NEW YORK STATE THRUWAY AUTHORITY
DEPARTMENT OF ENGINEERING

AMENDMENT NO. 1
TO

CONTRACT TAA 25-6B
D215009
REHABILITATION OF NYS THRUWAY (I-90)
BRIDGE OVER NYS ROUTE 5S / ERIE
CANAL RAIL TRAIL
AT MILEPOST 178.38
IN THE ALBANY DIVISION
IN MONTGOMERY COUNTY

| TITLE OF DRAWING PEDESTAL DETAILS (SHEET 4 OF 4) | DRAWING NUMBER: ST-21 |

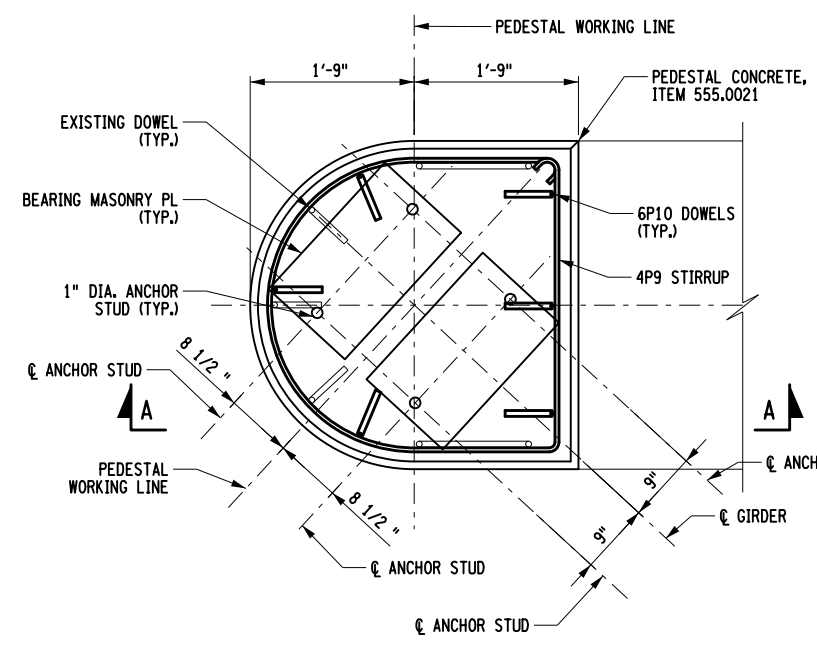
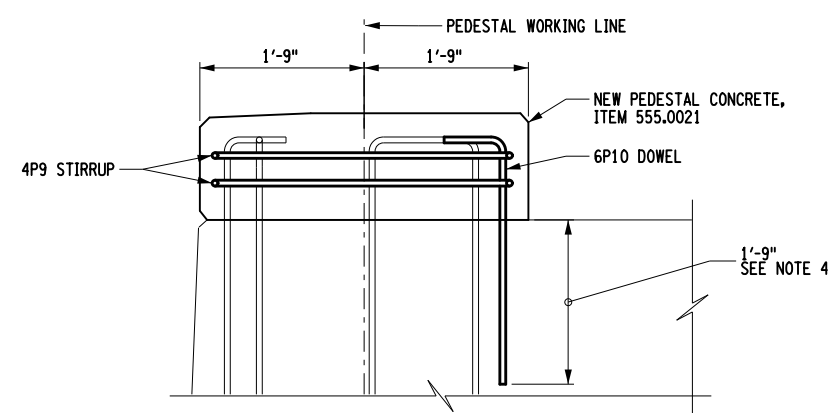
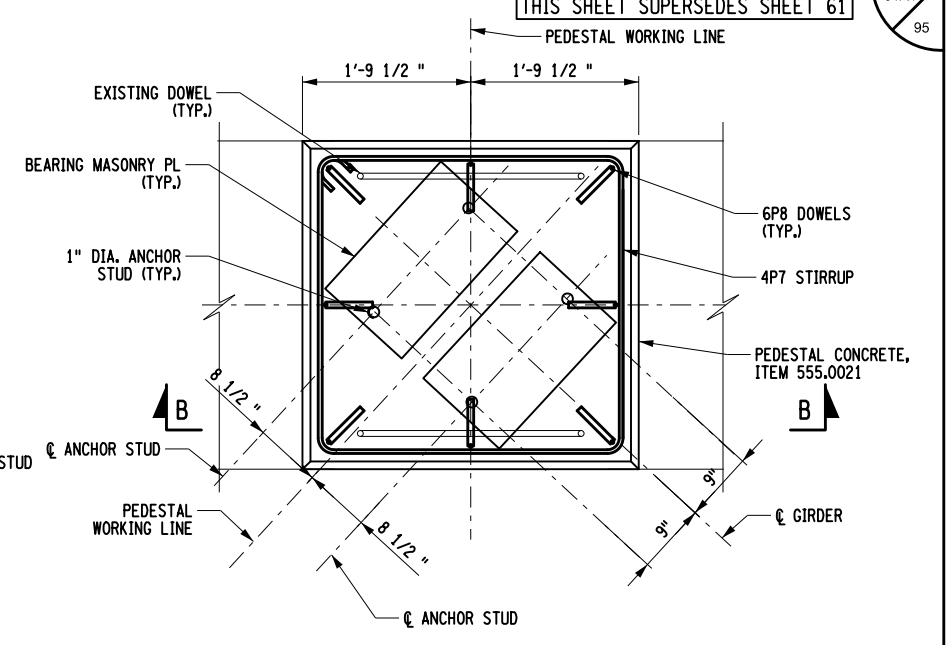
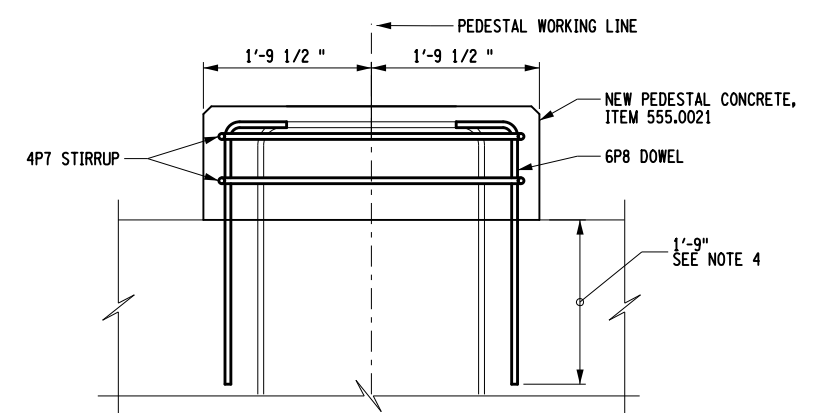
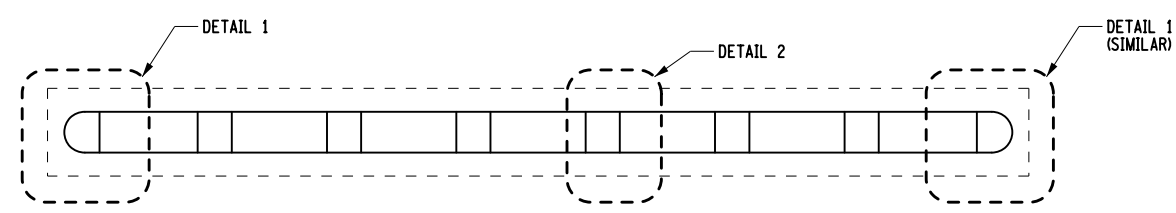
21. **DELETE** Drawing Number ST-21, sheet 61 of 95, and **SUBSTITUTE** with the attached Drawing Number ST-21, Sheet 61-A1 of 95. Note 4 was added to reflect the use of standard item number 586.0201 for drilling and grouting reinforcing bars.

| TITLE OF DRAWING TYPICAL STEEL DETAILS (SHEET 1 OF 3) | DRAWING NUMBER: ST-29 |

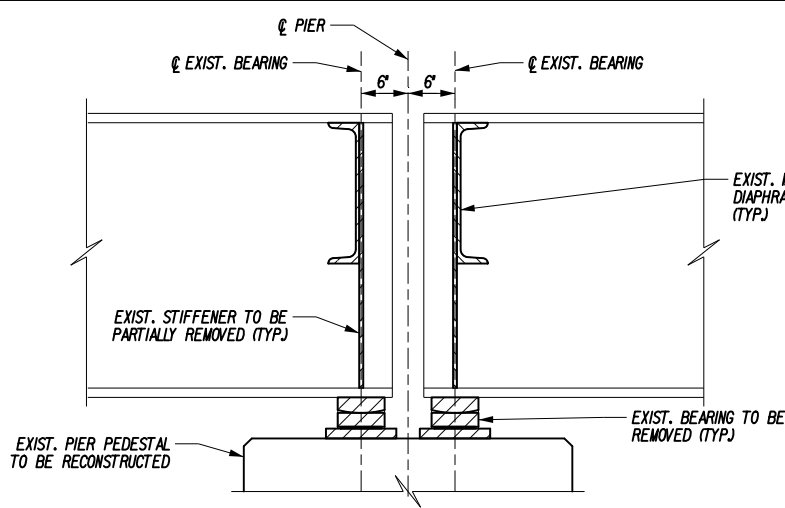
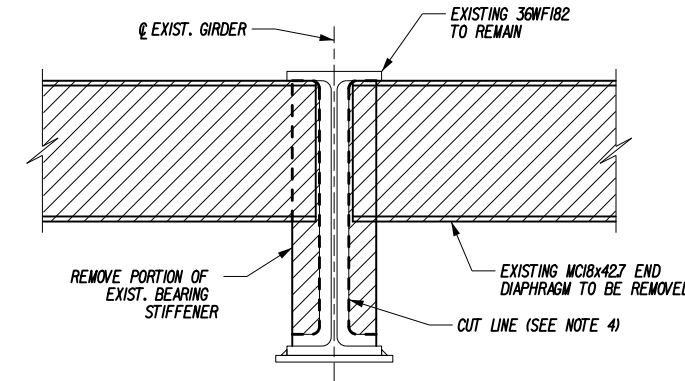
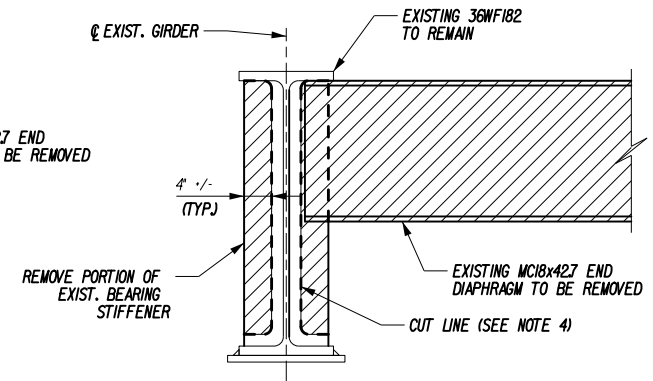
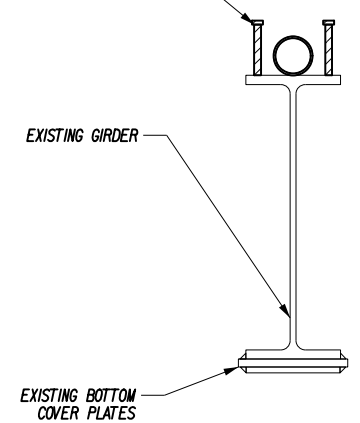
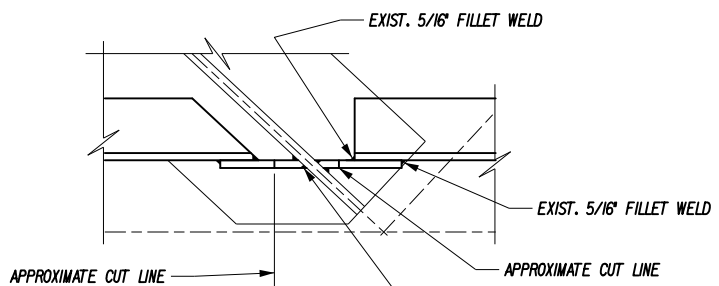
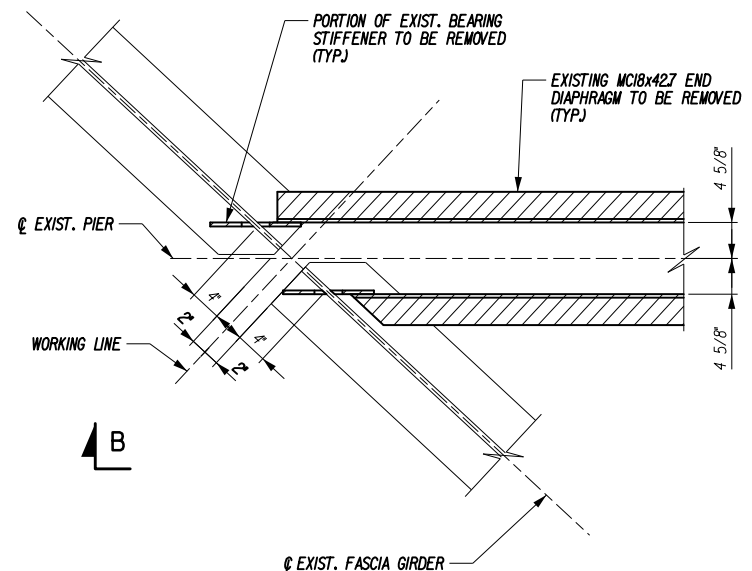
22. **DELETE** Drawing Number ST-29, sheet 69 of 95, and **SUBSTITUTE** with the attached Drawing Number ST-29, Sheet 69-A1 of 95. A Typical Girder Painting Limits detail was added to clarify the extent of field painting to be performed under item 574.9403--25.

| TITLE OF DRAWING APPROACH SLAB SECTIONS AND DETAILS | DRAWING NUMBER: ST-42 |

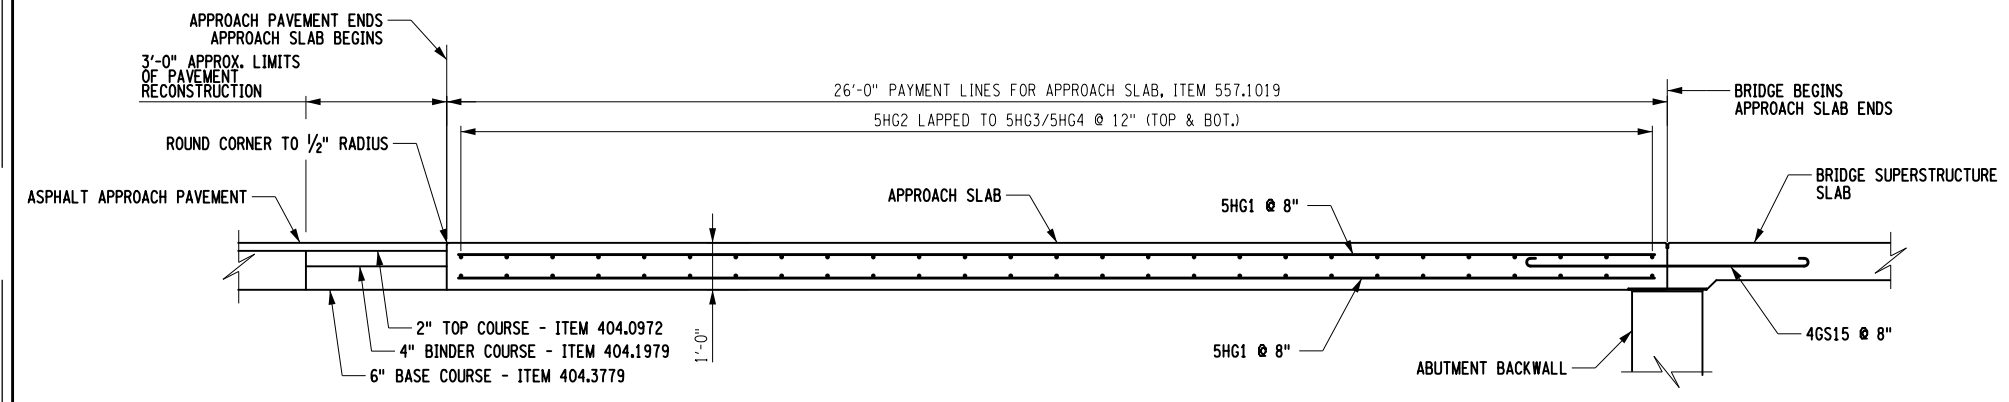
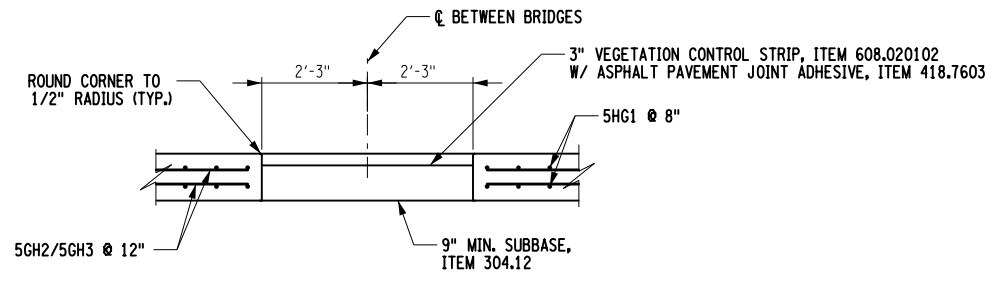
23. **DELETE** Drawing Number ST-42, sheet 82 of 95, and **SUBSTITUTE** with the attached Drawing Number ST-42, Sheet 82-A1 of 95. An approximate 3 ft. wide area of full depth pavement reconstruction was added to Section A-A to allow for additional excavation to construct the proposed approach slab.
